BABCOCK HILL FARMS

Review Date: AUGUST 11, 1988

Report Date: OCTOBER 1988

ENVIRONMENTAL REVIEW TEAM REPORT
ON
BABCOCK HILL FARMS SUBDIVISION
LEBANON, CONNECTICUT

WATERSHED BOUNDARY

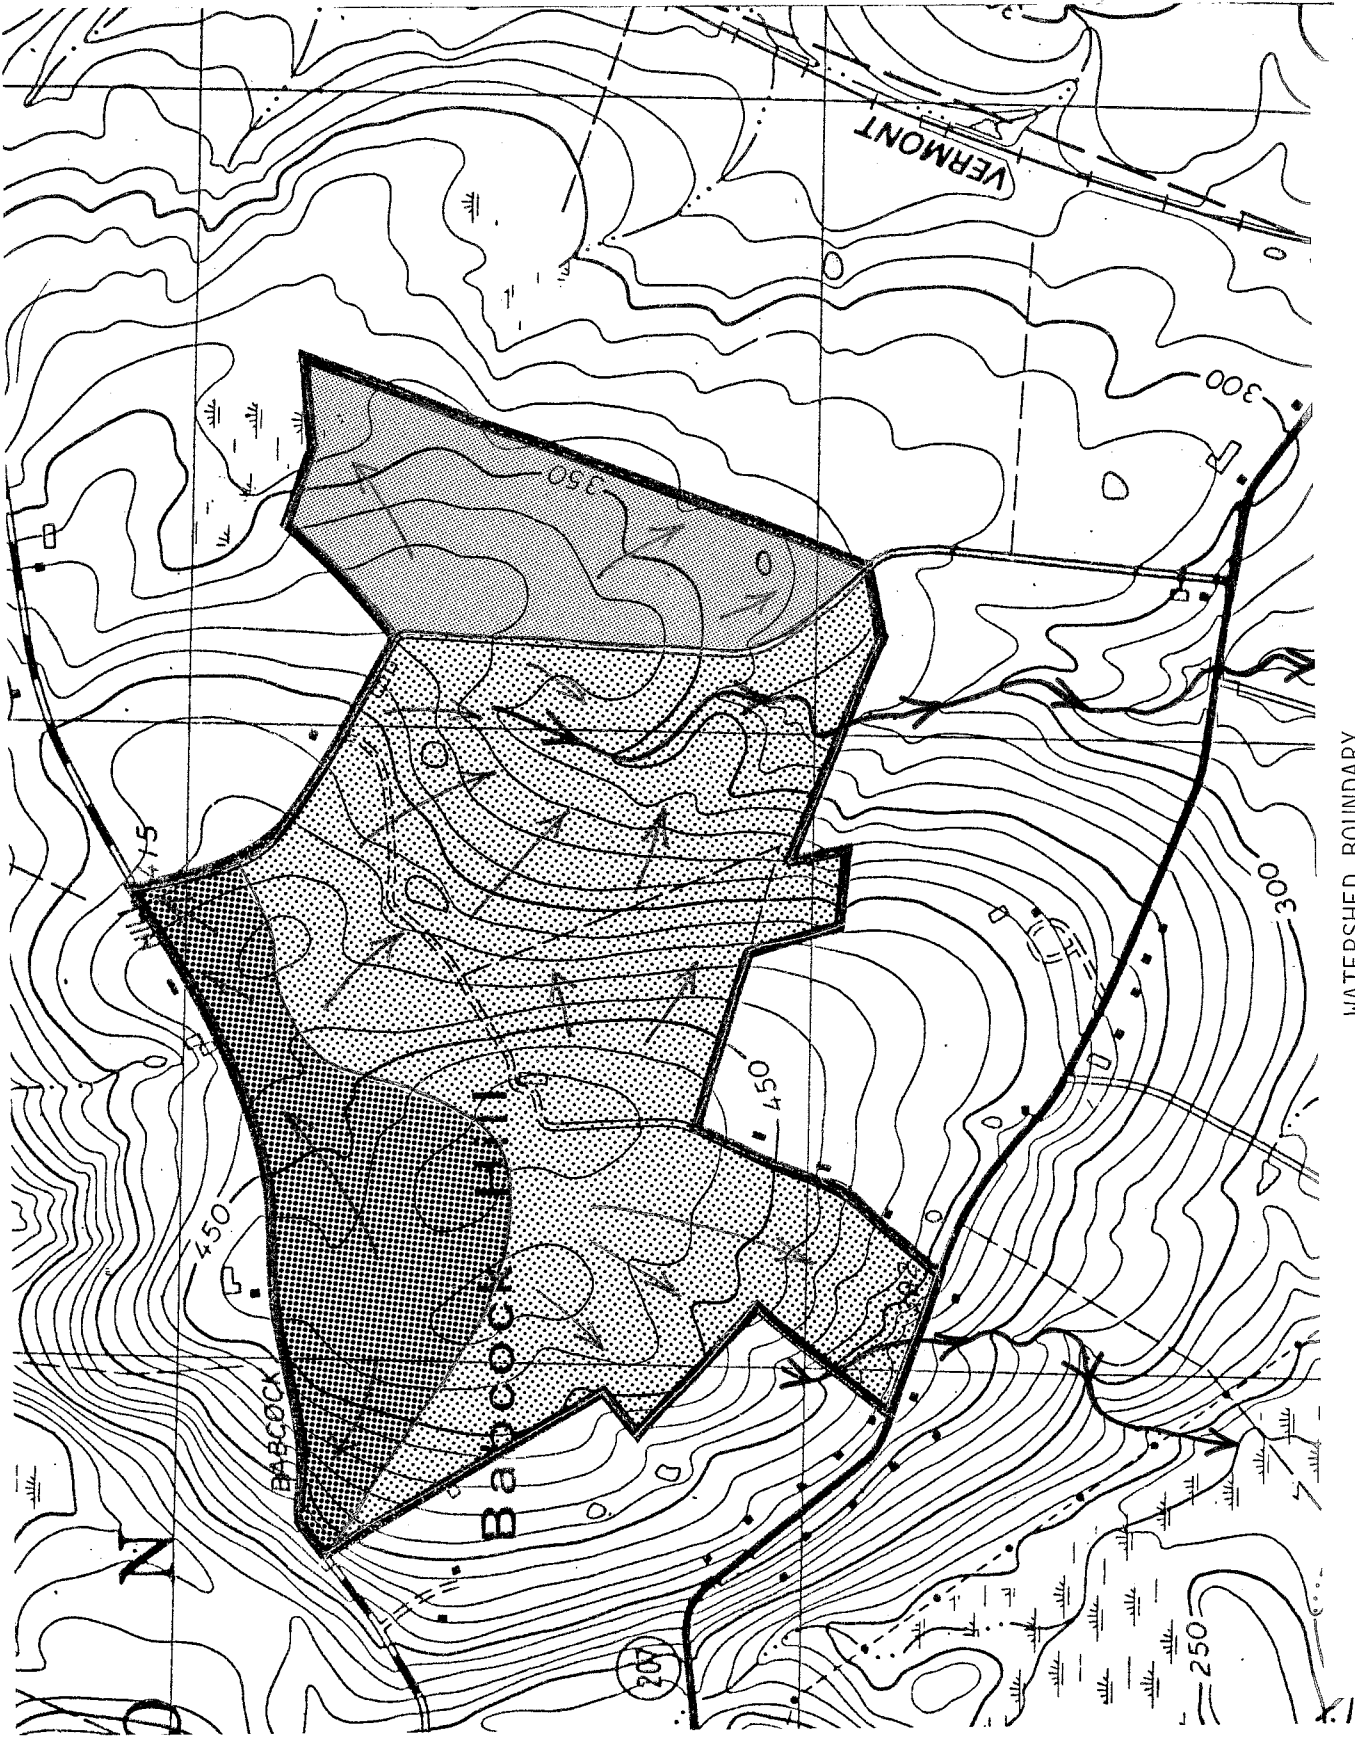
Following development of an 80 lot subdivision, one would expect that the amount of runoff shed from each subdrainage area during periods of rainfall would increase. These increases would arise mainly from soil compaction, removal of vegetation and placement of impervious surfaces (roof tops, driveways, etc.). However, most of the subject parcel consists of active cornfield (bare soils), which would tend to have a higher rate of runoff than a residential subdivision once lawns have been established. For example, according to Urban Hydrology for Small Watersheds (TR-55) a Soil Conservation Service method for estimating runoff conditions, cornfields are ascribed a curve number of 85 based on the soil types present within the site. On the other hand, a residential subdivision (two (2) acres in size) on the same land would be ascribed a curve number of about 75. Curve numbers relate to the amount of precipitation that falls on a given area to the amount of surface runoff that is produced. A higher curve number indicates that a greater volume runoff would occur following a given amount of runoff.

According to present plans, the project engineer is proposing a detention basin at the northwest corner of the site. The purpose of the detention basin is to handle post-development flows so that Babcock Hill Road is not overtopped by stormwater. The stormwater detention basin must meet all design criteria and standards found in the Connecticut Guideline for Soil Erosion and Sediment Control (1985).

Finally, it would be helpful if the project engineer prepared a written report for the stormwater management plan that includes the following (1) initial conditions and storm frequencies to be analyzed; (2) summary table showing the pre-development, post-development and designed system peak discharges for all frequencies; and (3) sketch of the structures outlet system with elevations and dimensions.

The protection of watercourses on and off site from silt and road sand is a major concern. In this regard, a comprehensive erosion and sediment control plan would be essential to the assessment of the development, particularly in view of the moderately steep slopes in places, silty, bare soils, and seasonal seeps that characterize the site. It seems likely that the retention basin could be combined to serve a sediment-retention function. Provisions for maintenance and access to the basin will need to be considered. Maintenance of the sediment/retention basin on a regular basis is most important. If sediment/road sand accumulates in the basin, it could seriously deplete the runoff storage capacity of the basin.

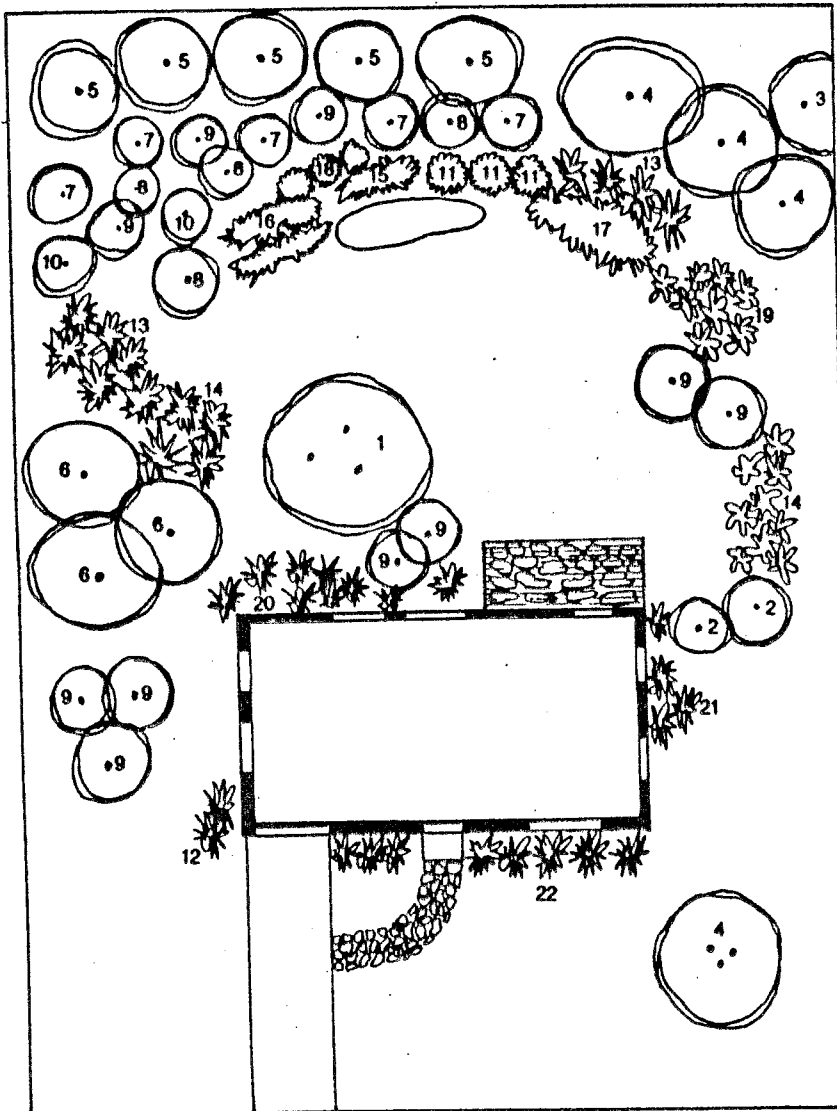
The major area of concern on the property is the wooded section in the south western corner. This area currently offers a high diversity of wildlife habitat for a number of wildlife species and is the most utilized area of the property. The mixed hardwood overstory combined with wetland vegetation provides an unique area for wildlife. The overstory is dominated by red oak, white oak, ash shagbark hickory, and red maple. The understory consists of viburnum, spice bush, multiflora rose, grape and a variety of wetland vegetation. Jewel weed, white snake root, horse-balm, green briar, and a variety of ferns dominate the area at ground level.

Unfortunately this area has been subdivided into twelve lots (lots #1-#12). It would be beneficial to wildlife if as much of this area as possible was designated as open space. This could be substituted by a reduction in the size of the areas presently designated as open space. The areas currently designated as open space offer little diversity of wildlife habitat. Decreasing their size would not have adverse affects on wildlife.
